Response Letter

The paper submitted by Li et al. describes a permafrost dataset compiled from measurements made along an oil pipeline route in NE China. The dataset includes information on ground temperatures, soil moisture along with results of geophysical surveys and meteorological data. Instrumented sites are located at various distances from the pipeline and are both on the right-of-way (ROW) and in undisturbed terrain off the ROW which facilitates characterization of impacts of pipeline characterization, similar to that done along other pipelines (e.g. Burgess and Smith 2003; Burgess et al. 2010; Johnson and Hegdel 2008). Such datasets and associated analysis are valuable because they can be utilized for model calibration and validation and also to evaluate mitigation techniques to reduce impacts and improve design of future infrastructure projects (e.g. Burgess et al. 2010). For these reasons, the paper and associated database should of interest to engineers and those involved in environmental impact assessment. However the manuscript does require a number of revisions before it can be accepted for publication.

Figure 4. Relationship between latitude and GT along the route of China-Russia Crude Oil Pipelines (CRCOPs).

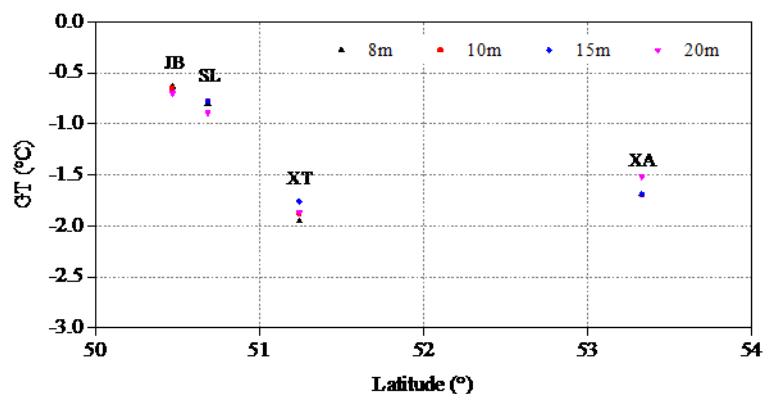
L190 – Fig. 3b doesn't clearly show the relationship between GT and latitude and whether it is linear or not. MAGT at DZAA for each undisturbed site could be plotted vs latitude to better show this.

As shown in Figure 3b, the annual changes of ground temperatures at the depth of 15m at all monitoring sites are negligible except for the JS site. This depth is considered as the depth of zero annual amplitude (DZAA). The MAGTs at DZAA at the sites of JB, SL, XT, and XA are -0.7 , -0.8 , -1.8 , and -1.7°C respectively, indicating that the MAGT at DZAA is greatly affected by the latitude, but the relationship between MAGT and latitude is not linearly dependent, as shown in Figure below, which was added in the revised manuscript and numbered Figure 4.

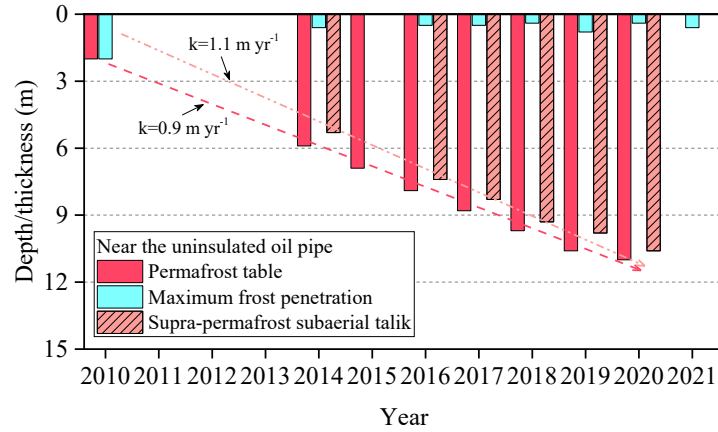
L225 – It isn’t clear why this is an artificial permafrost table – is this the site with thermosyphons? If so, it should be mentioned first.

We are sorry for this mistake. It was changed to the permafrost table. Meanwhile, this paragraph has been rewritten and some necessary information has been added in Figure 8.

‘The time-series of the depths of the permafrost table and maximum frost penetration in borehole JB-B-1, horizontally 2 m away from the uninsulated pipe centerline at the JB site shows that since the official operation of CRCOP I starting in 2011, the depth of the permafrost table has been increasing with an average rate of 0.9 m yr⁻¹ and depth of seasonal frost penetration decrease

rapidly and then varies little (0.4-0.8 m) during 2010–2021 (Fig. 8). Therefore, a thawed interlayer between permafrost table and the bottom of seasonal frost (i.e., supra-permafrost subaerial talik, SST) formed and developed with an average rate of 1.1 m yr⁻¹ in the same period.’.

Revised as Figure 11 in the new version.

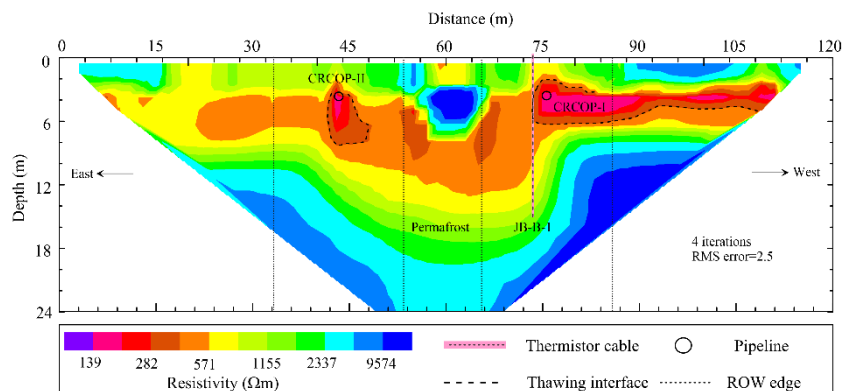
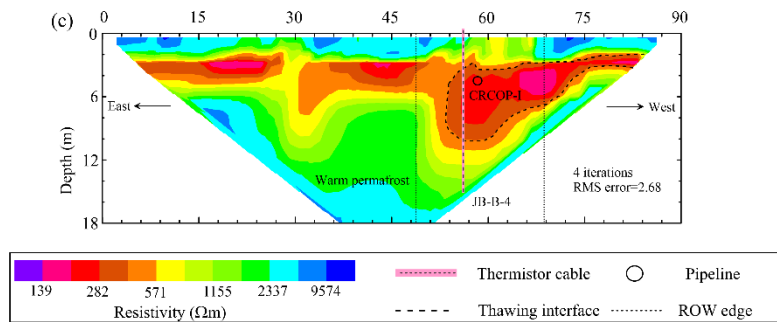
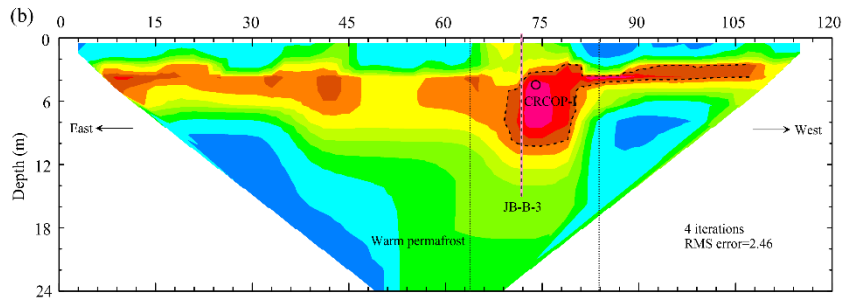
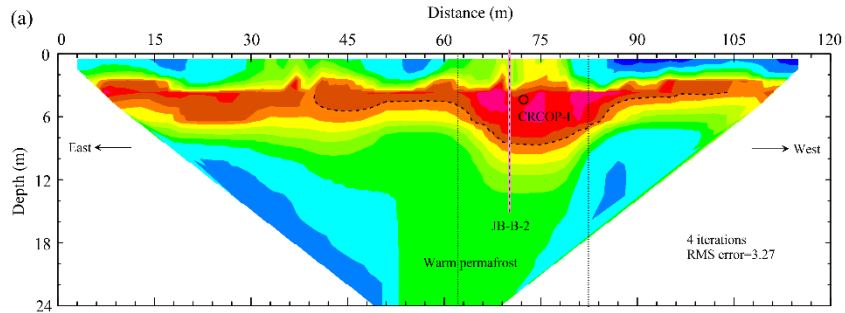
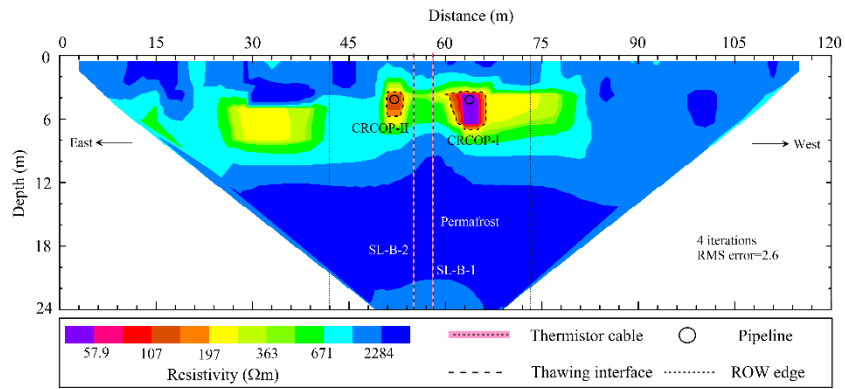
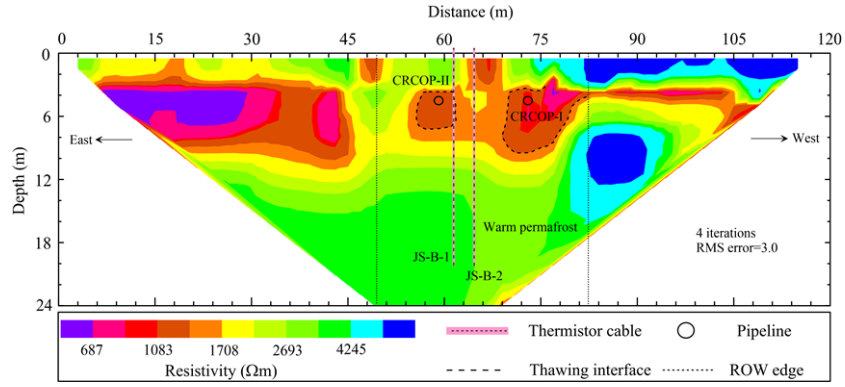
L245 – Figure 8 – Consider reversing the colour scale and using blue for higher resistivity (colder ground –permafrost) and red for lower resistivity (warmer ground – unfrozen). This is more intuitive and has been done in other papers presenting ERT results. If some of the transect is off ROW, indicate the ROW edge. Was there a topographic survey done? – no change in ground elevation is shown.

10, In Figure 8 and Appendix D, please use blue for higher resistivity and red for lower resistivity in ER images, like the color scheme in Figure 9. This is more intuitive for readers.

Thank you for your comments. The ERT surveys have been conducted at JB, SL, and JS sites. These three sites are selected on relatively flat terrain and there are no obvious changes in ground elevation. Thus, the ground surface varies little in elevation in RET images. The color for ERT images has been changed in this figure and appendix D based on your suggestion. The updated figures are shown below:

We re-draw Figure 8 (revised as Figure 11 in the new version) and Appendix D according to your suggestion. More detail can be found in Section 1.2 in this file.

Figure 7. Variations in ground temperatures at the depth of 3 m on the right-of-way (ROW) at the JS (a), SL (b), and JB (c) sites along the China-Russia Crude Oil Pipeline (CRCOP) I in northern part of Northeast China during 2017–2021.

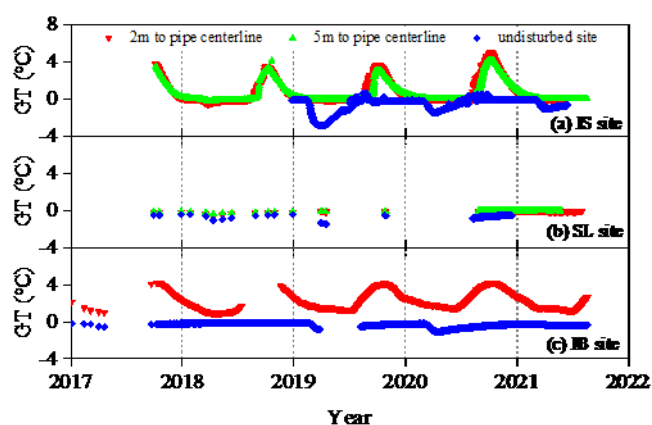
Figure 6: To facilitate comparison, I suggest using the same range of values in the vertical axis (GT) for each subfigure. (Same for the left and right panels in Fig. 3)

We re-draw Figure 6 (revised as Figure 7 in the new version) according to your suggestion.

Figure 12. Dependence of electrical resistivity on ground temperature and lithology.

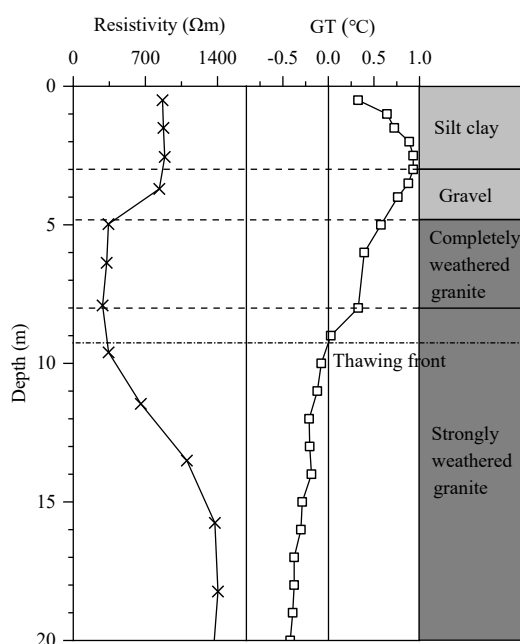
Line 234-236: Why you used 300 ohm·m here? In my knowledge, this value can vary greatly from place to place around the world. The authors should give a criterion or any references to support their choice (e.g., Schön, J. H., 1996; Christof Kneisel et al., 2008). Also, you said “boundary”, it is a little bit confusing. I understand you mean the boundary between unfrozen and frozen zones. So, my suggested wording is: electrical resistivity value of 300 ohm·m was used as the critical value to identify the boundary between frozen and unfrozen zones.

What you said is right. We selected a threshold value of electrical resistivity for discriminating between frozen and unfrozen zones according to the relationship between the resistivity, ground temperature, and lithology, as shown in the Figure below (added in the revised version and numbered Figure 12). The related description has been revised according to your comment.

‘Here, an ER value of 300 Ωm was used as the critical value to identify the boundary between frozen and unfrozen zones combined with the profile characteristics of resistivity, GT, water/ice content, and lithology (obtained from borehole drilling) (Fig.12).’
